Submission from the Building and Construction Department of the City University of Hong Kong

Figure 1 Noise barrier with insufficient height at Cheung Ching Estate

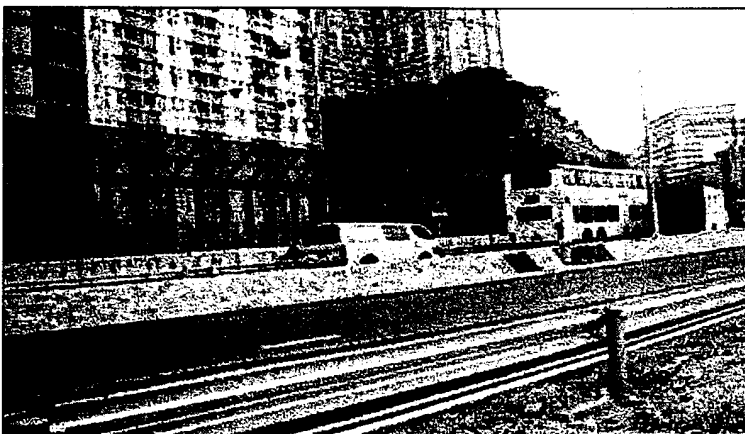
It was found that many existing barriers that were not improperly designed and installed could not achieve their expected noise reduction due to insufficient height, insufficient length, and gaps (see figures 1 to 3). In order to ensure that the residents do get the benefits from the programme, some suggestions are listed below.

- The detail design and on-site installations must be approved by qualified acoustic engineers to ensure the effectiveness of noise barriers.
- There should be a post-commissioning test to ensure whether the noise barriers can achieve their design noise reduction capability for future design reference.
- It should be performed by independent laboratory with recognized quality assurance certificates. (that has been implemented in most civil projects but not required in previous barrier projects in which only the overall barrier length and height were checked.)
